# CITY OF ALBUQUERQUE

March 30, 2017

RE: **Lot 13 Block 10 Unit 22 Volcano Cliffs SAD 228**  
**6300 Petirrojo NW**  
**Grading and Drainage Plan**  
**Engineers Stamp Date 3/22/17 (D10D003F13A)**

ENGINEER'S SEAL	6300 PERIRROJO	DRAWN BY WCVJ
		DATE 3-20-17
		21721-LAYOUT-3-20-17
3/22/17	GRADING AND DRAINAGE PLAN	SHEET # —
DAVID SOULE P.E. #14522		JOB # 21721
	Rio Grande Engineering 1606 CENTRAL AVENUE SE SUITE 201 ALBUQUERQUE, NM 87106 (505) 872-0089

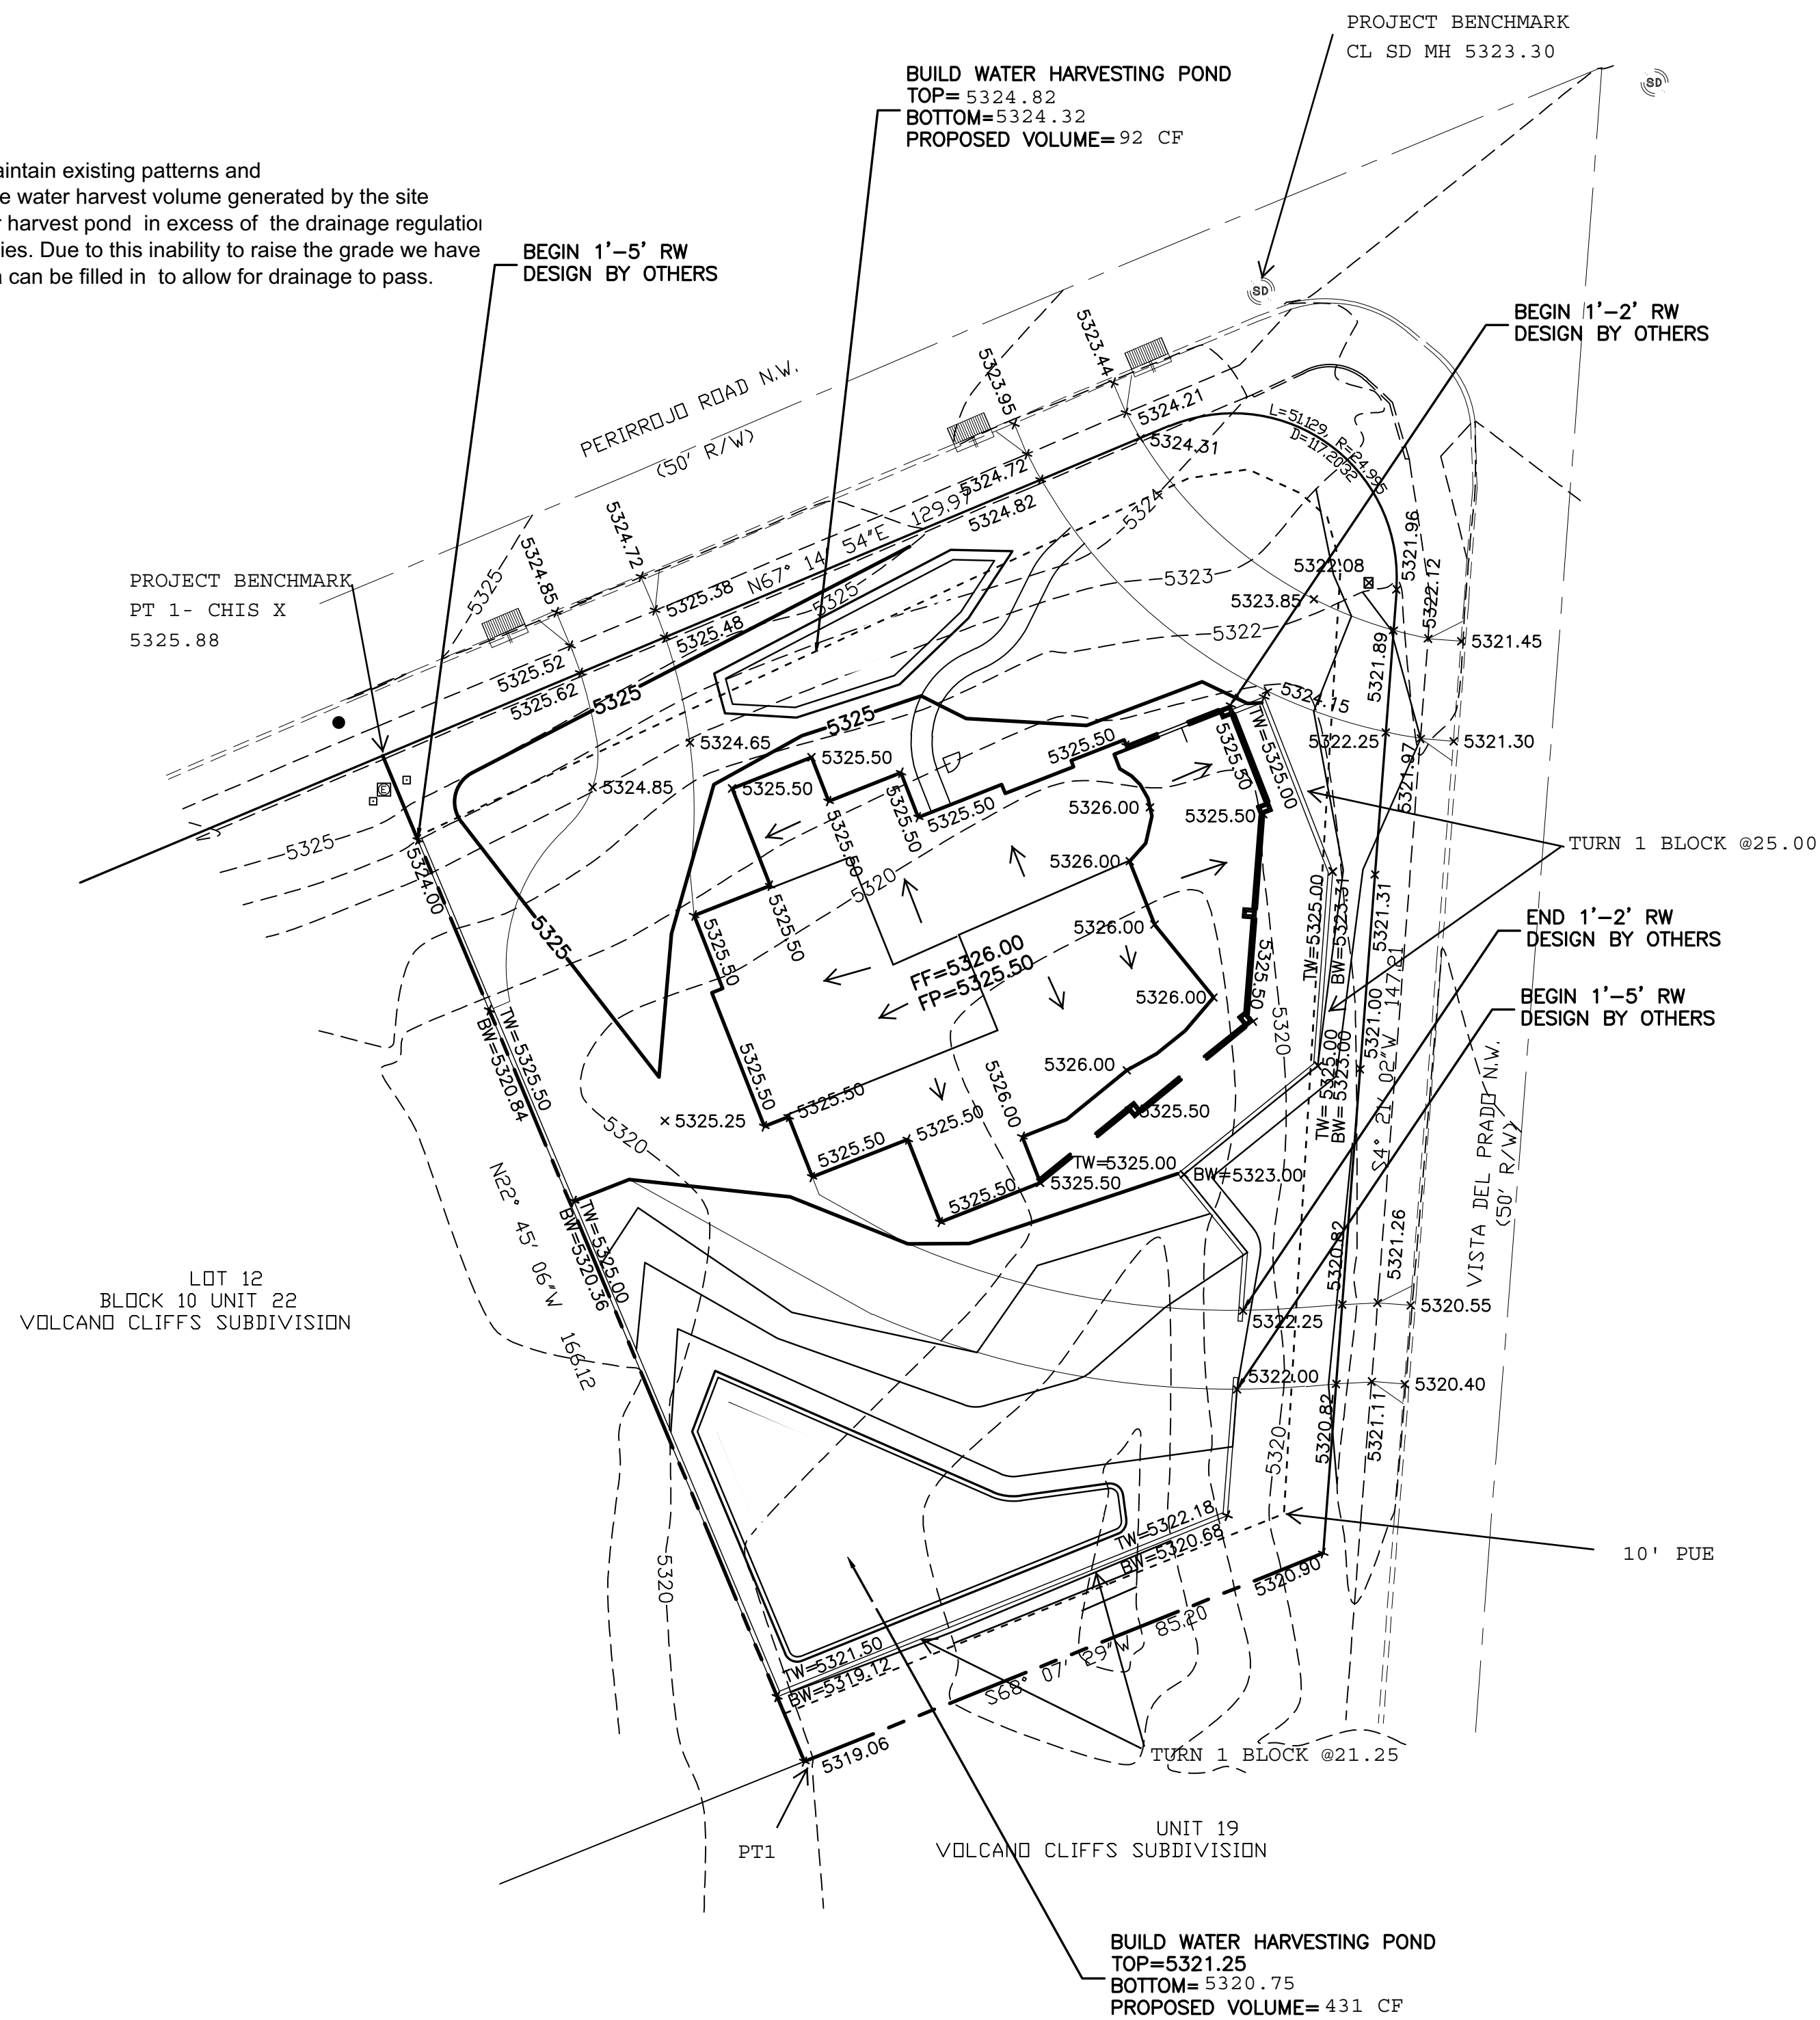
Based upon the information provided in your submittal received 3/28/17, this plan is approved for Grading Permit. **Prior to building permit approval, a pad certification will be required.** A hold on the property will be placed until this certification has been approved.

Please inform the builder/owner to attach a copy of this approved plan to the construction sets in the permitting process prior to sign-off by Hydrology. Reiterate to the Owner/Contractor that a separate permit for a garden/retaining wall must be obtained, with the approved G&D plan dated 3/22/17.

Prior to Certificate of Occupancy release, Engineer Certification per the DPM checklist of this plan will be required.
